# Charlotte Land Development Standards Manual (CLDSM)

Revision N<sup>o</sup>. 14  
July 29, 2016

## CLDSM REVISION LOG

TYPE II-MODIFIED DRIVEWAY DETAIL WITH  
WIDE PLANTING STRIP AND STANDARD CURB

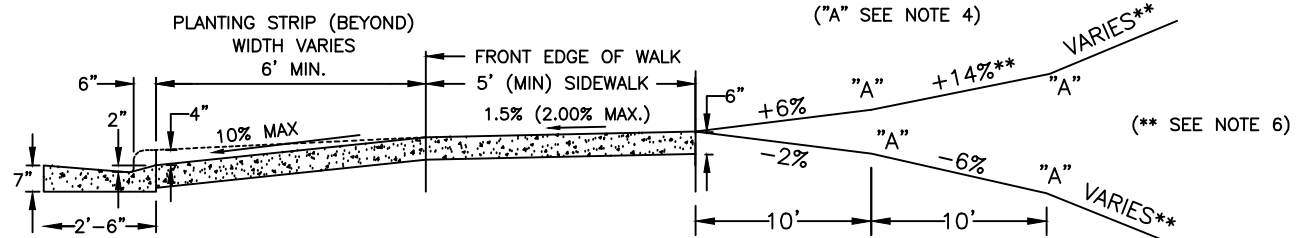
REVISION NO.	REVISION DATE	STANDARD No.	NAME	DESCRIPTION OF REVISION
14	7/29/2016	10.25E	Type II-Modified Driveway Detail With Wide Planting Strip and Standard Curb	Added Note #9 re: driveway rise 6" from gutter flow line
14	7/29/2016	10.28	Type III Driveway Entrance	Added note #7 re: 2% cross slope on crosswalk; notes and drafting updated for clarity of detail near ramps
14	7/29/2016	10.31A	Curb Ramp Standard with Planting Strip 2'-6" Curb and Gutter (plan view)	Changed name to "Perpendicular Curb Ramp"; adjusted ramp plan and section for 8' planting strip; adjusted flowline depth to avoid non-accessible slope break previously shown
14	7/29/2016	10.31B	Accessible Ramp Section with Planting Strip 2'-6" Curb and Gutter (section view)	Replaced previous detail with isometric views of perpendicular ramps
14	7/29/2016	10.32A	Accessible Ramp Standard without Planting Strip 2'-6" Curb and Gutter (plan view)	DETAIL REMOVED

8. JOINT MATERIAL SHOULD BE PLACED FLUSH WITH CONCRETE.
9. THE DRIVEWAY MUST RISE 6" FROM THE GUTTER LINE TO PREVENT RUNOFF FROM ENTERING DRIVEWAY.

PERPENDICULAR CURB RAMP  
WITH 2'-0" VALLEY GUTTER

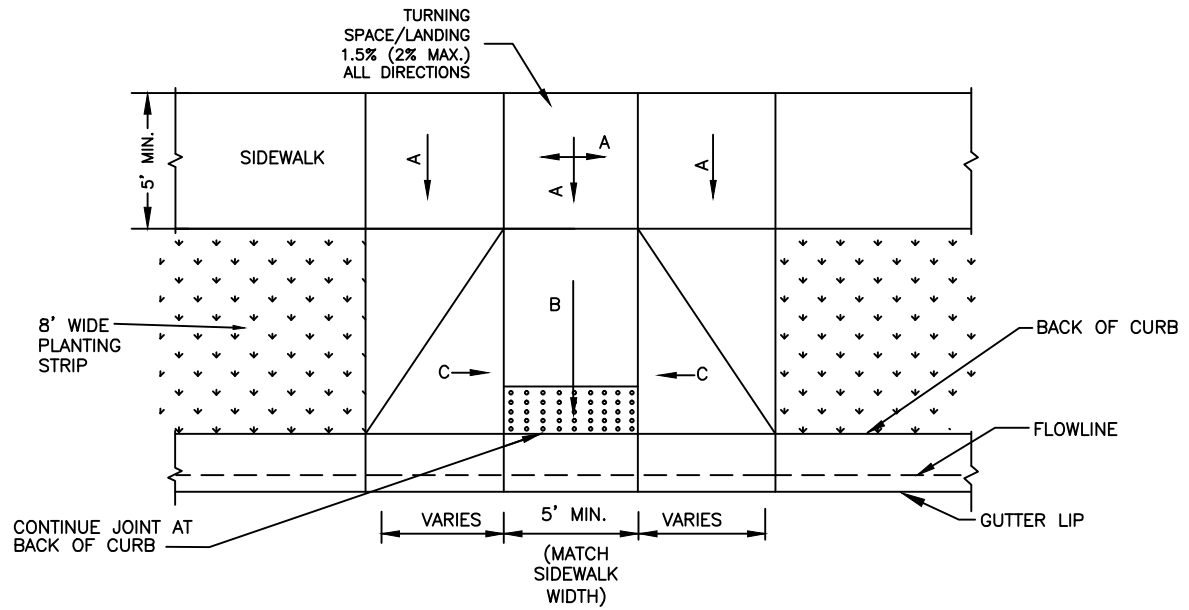
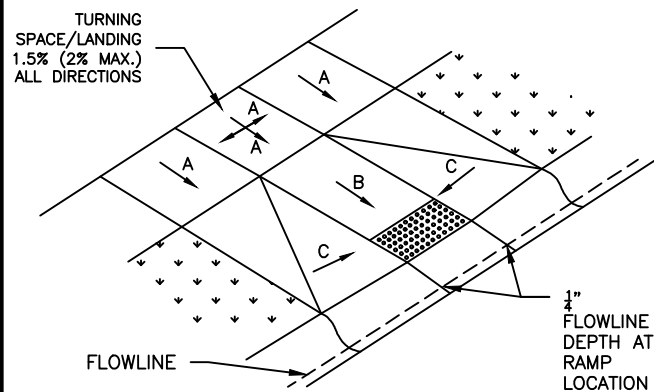
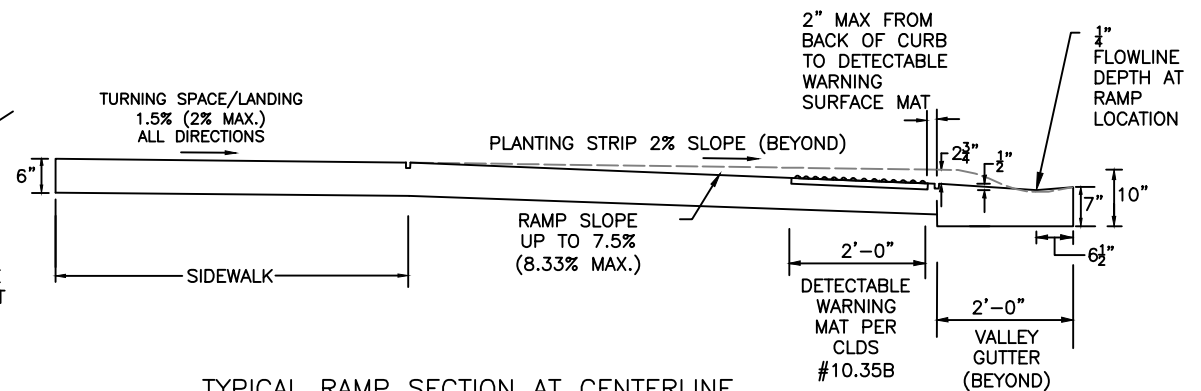
14	7/29/2016	10.32B	Accessible Ramp Sections without Planting Strip 2'-6" Curb and Gutter (section view)	DETAIL REMOVED
14	7/29/2016	10.33	Accessible Ramp Standard 2'-0" Valley Gutter (plan view)	Changed name to "Perpendicular Curb Ramp", Single detail 10.33 now supercedes previous 10.33A and B; added isometric view; adjusted flow line depth to avoid non-accessible slope break previously shown
14	7/29/2016	10.33B	Accessible Ramp Sections 2'-0" Valley Gutter (section view)	DETAIL REMOVED
14	7/29/2016	10.34A	Accessible Ramp Standard Monolithic Curb and Sidewalk	DETAIL REMOVED
14	7/29/2016	10.34B	Accessible Ramp Sections Monolithic Curb and Sidewalk	DETAIL REMOVED
14	7/29/2016	10.35A	Standard Placement of Accessible Ramp and General Notes	Clarified note re: turning space for both views!; added in Slope "A" on landing space on both details; changed name to "Curb Ramp" instead of "Accessible Ramp"; Added notes 8, 9, 10; included detail showing 4x4 crosswalk clear zone; added min. curb height at corners 2"

# DIRECTIONAL CURB RAMP WITH SMALL/MEDIUM CURB RADII

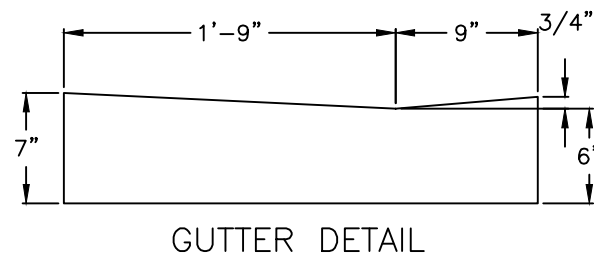
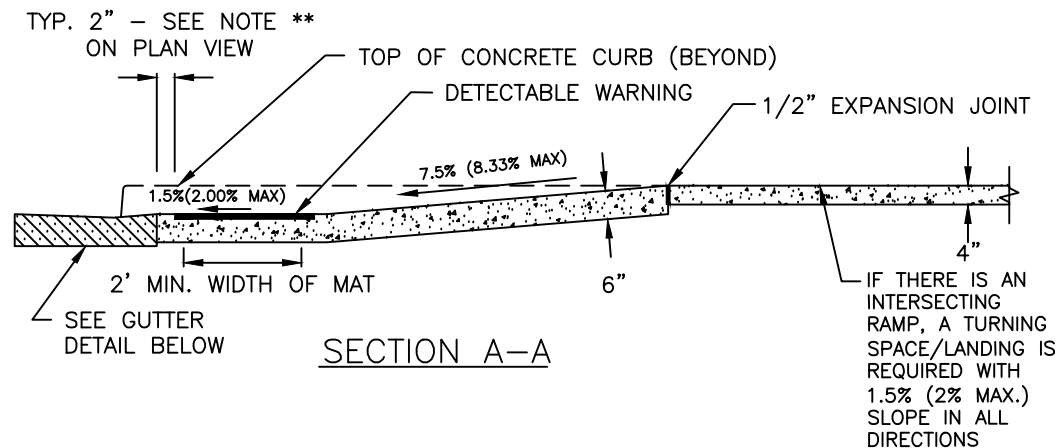
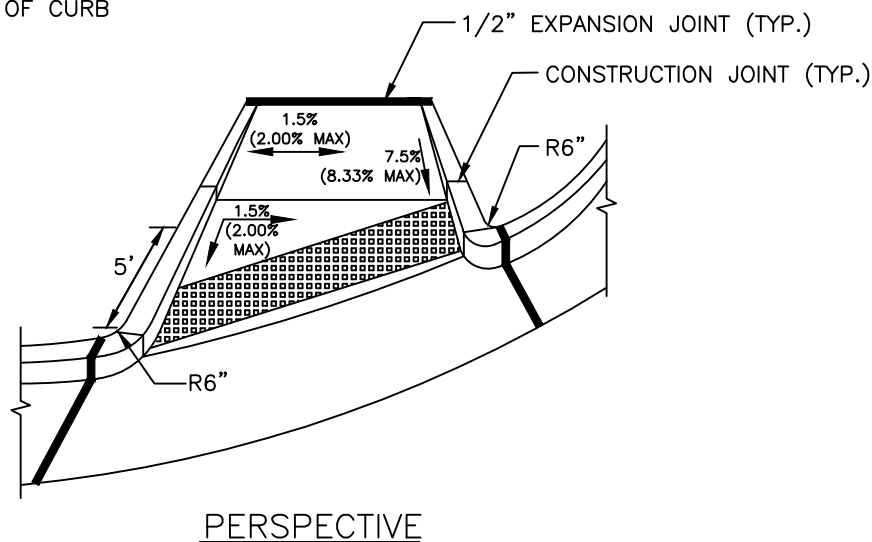
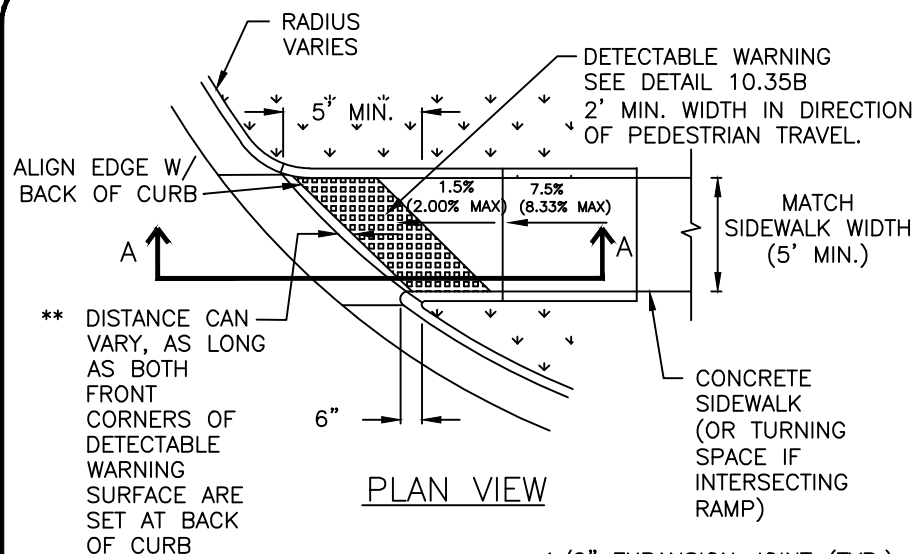
14	7/29/2016	10.40A	Directional Accessible Ramp (Small Radius)	Changed name to "Directional Curb Ramp"; added note re: 2% landing if intersecting ramp.
14	7/29/2016	10.40B	Directional Accessible Ramp (Large Radius)	Changed name to "Directional Curb Ramp"; added note re: 2% landing if intersecting ramp.
14	7/29/2016	10.41A	Pedestrian Refuge With 1'-0" Curb and Gutter	New Detail
14	7/29/2016	10.41B	Pedestrian Refuge With Vertical Curb	New Detail
14	7/29/2016	10.41C	Pedestrian Refuge With Modified Monolithic Curb	New Detail
14	7/29/2016	Text Pg. 9, 10	Section F. "Sidewalks, Curb Ramps, and Driveways"	Changed section name to include "curb ramps,;" Included PROWAG statement as F.1; adjusted various notes to meet PROWAG.
